June 25, 1999

Addendum To Risk Based Corrective Action Assessment For Soil

Beck Roofing Company, 21123 Meekland Avenue, Hayward, CA

Benzene Downgradient Extent in Soil

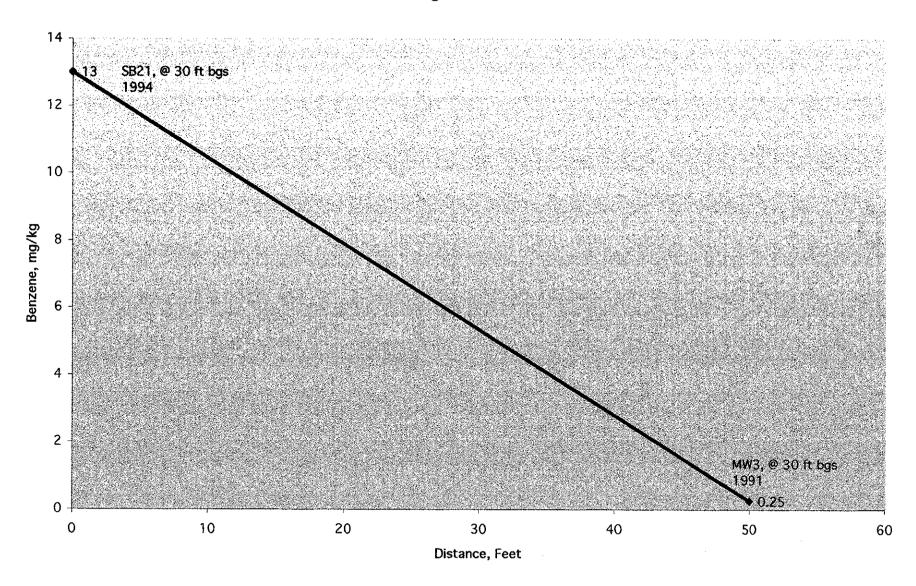
Ms. Logan stated that Alameda County does not permit inclusion of biodegradation factors in degradation calculations. The calculations were redone using field data for points adjacent to SB21, the contamination source location, in the down and cross gradient directions. Soil data for SB21 and MW3 were used to determine the down gradient extent of contamination. Soil data for

SB21 and MW 1 were used to calculate the cross gradient extent of contamination. A simple linear graphical solution was used to determine the distance from the source of contamination, SB21, to a zero concentration level. The resulting graphs show the down gradient extent of contamination at 51.5 feet from SB 21, and a lateral extent of contamination at 49 feet from SB21. The office building is 60 feet away from SB21 in the cross gradient direction and about 50 feet in a direction diagonally between down and cross gradient.

The plume of benzene does not reach or extend under the office or warehouse building, based on the graphical solutions using 1991 and 1994 soil data for 25 and 30 feet bgs. Therefore, the soil to indoor air pathway is expected to be incomplete and not present a significant health risk at Beck Roofing.

Benzene Downgradient Extent in Soil

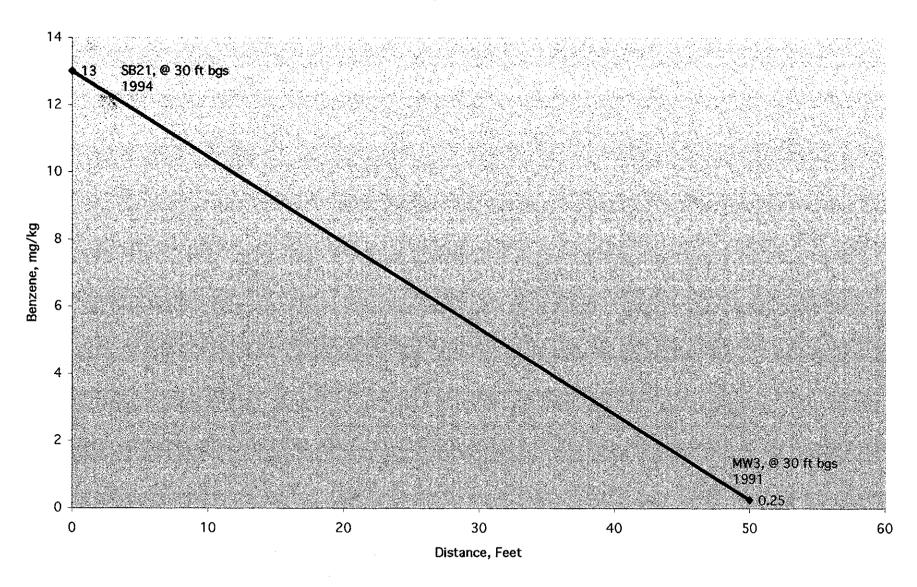
Ms. Logan stated that Alameda County does not permit inclusion of biodegradation factors in degradation calculations. The calculations were redone using field data for points adjacent to SB21, the contamination source location, in the down and cross gradient directions. Soil data for SB21 and MW3 were used to determine the down gradient extent of contamination. Soil data for

SB21 and MW 1 were used to calculate the cross gradient extent of contamination. A simple linear graphical solution was used to determine the distance from the source of contamination, SB21, to a zero concentration level. The resulting graphs show the down gradient extent of contamination at 51.5 feet from SB 21, and a lateral extent of contamination at 49 feet from SB21. The office building is 60 feet away from SB21 in the cross gradient direction and about 50 feet in a direction diagonally between down and cross gradient.

The plume of benzene does not reach or extend under the office or warehouse building, based on the graphical solutions using 1991 and 1994 soil data for 25 and 30 feet bgs. Therefore, the soil to indoor air pathway is expected to be incomplete and not present a significant health risk at Beck Roofing.
